32ND UNECE VRU PROXI GROUP: POTENTIAL AMENDMENT TO ENSURE FRONTAL DIRECT VISION REQUIREMENTS -UPDATED

CONCERNS RAISED BY MANUFACTURER SUGGEST DESIGN CHANGES TO MEET THE STANDARD

Redesigned dashboard on the passenger side

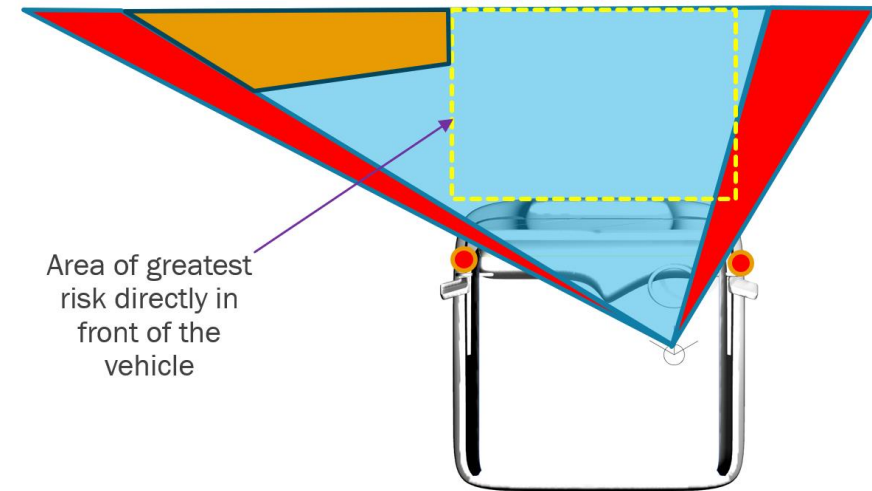
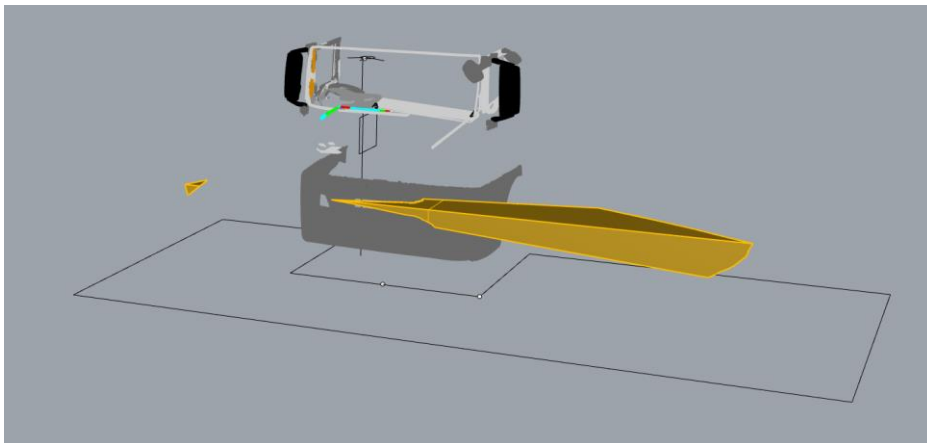
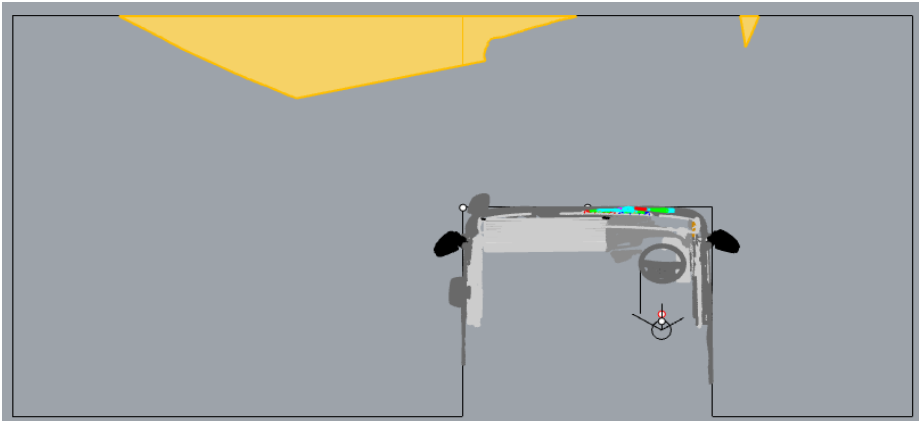
- Manufacturers (ACEA) have mentioned that lowering the Passenger side dashboard is an option for meeting the frontal requirements.
- The analysis that we performed and showed below highlighted that this kind of design change would not improve direct vision directly in front of the vehicle, or the area of greatest risk for pedestrian VRUs.

Orange areas show volume gained outside of area of greatest risk for frontal collisions, **potentially allowing a vehicle to pass the minimum requirements without improving direct vision directly in front of the vehicle in the area of greatest risk.**

Original vehicle design

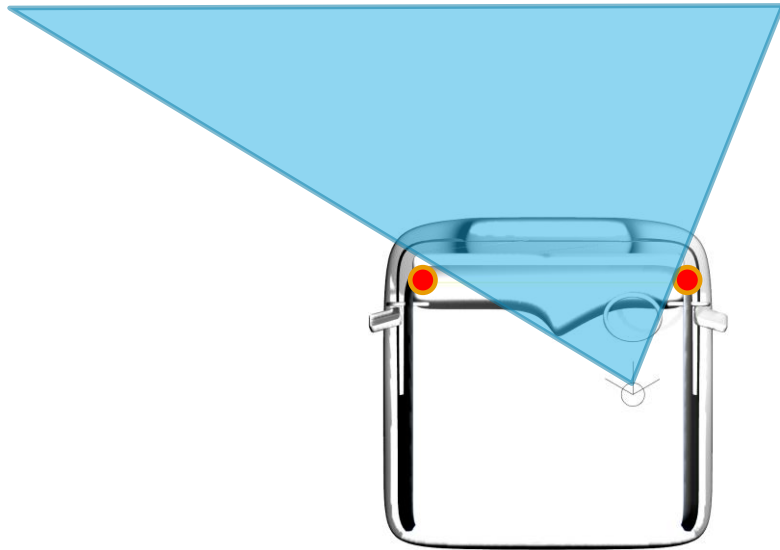
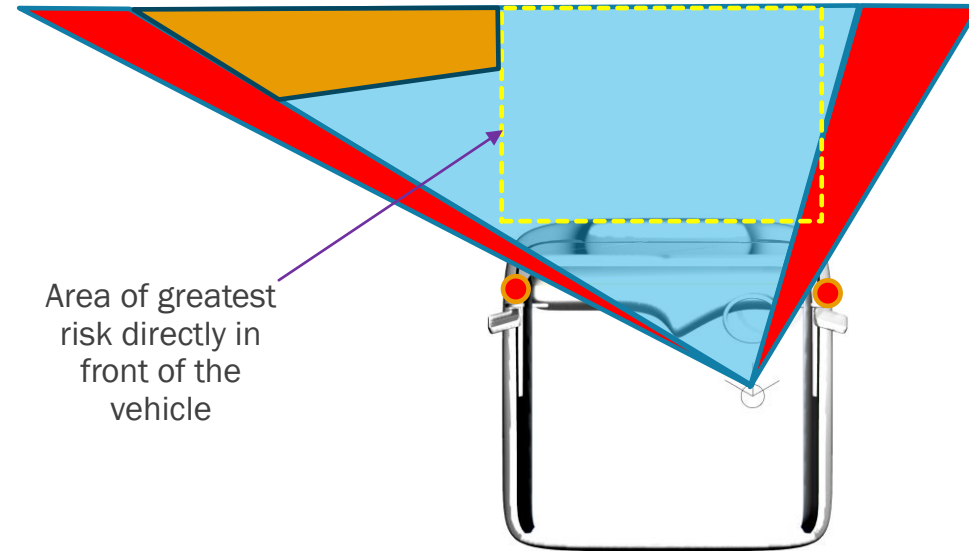
- By requiring a design to allow visibility of the **Subsection Frontal Visible Volume (SFVV)** area we can avoid the issue shown below.

Redesign moves A-pillars rearwards

Red areas show volume gained outside of area of greatest risk for frontal collisions, potentially allowing a vehicle to pass the minimum requirements without improving direct vision directly in front of the vehicle.

ADDRESSING ACEA CONCERNS RAISED AT THE 126TH GRSG

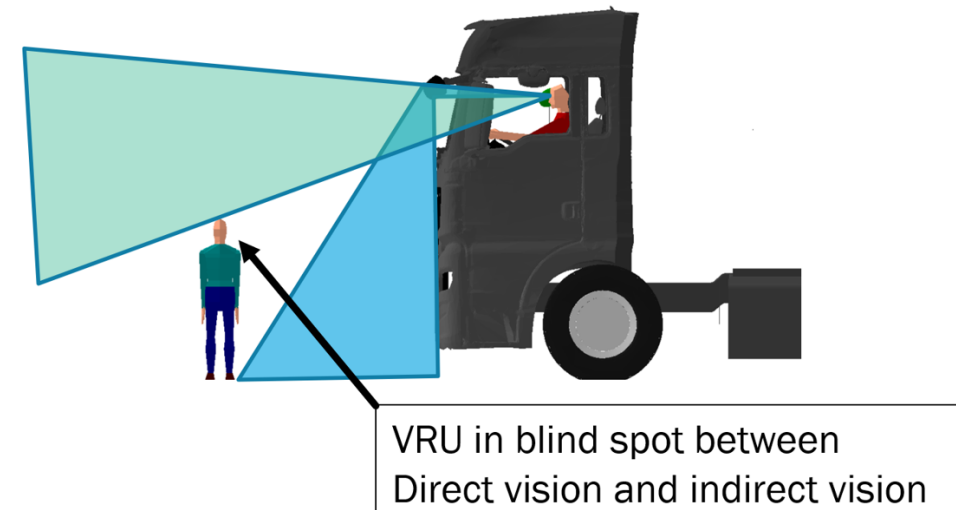
- One concern that was raised by ACEA at the 126th GRSG was the ability of the physical testing method to accurately measure the smaller limit for level 2 & 3 (**new version 0.17m³**) due to the tolerances that defined in the Reg 167 (0.1m³)

- We would like to know if any work has been done with Type Approval Authorities to further develop the physical testing method? The physical testing method was a prototype which would require significant development with a considerable investment

- This investment would seem unlikely as the digital method is much more cost effective
- A simple solution would be to set a requirement of 0.2m³ for Level 2 and 3 vehicles, requiring at least 0.1m³ to be visible with the tolerance applied

- The Digital test method is highly accurate and so we don't see a problem with this
- Currently there are several cab designs which do not allow ANY SFVV volume to be seen
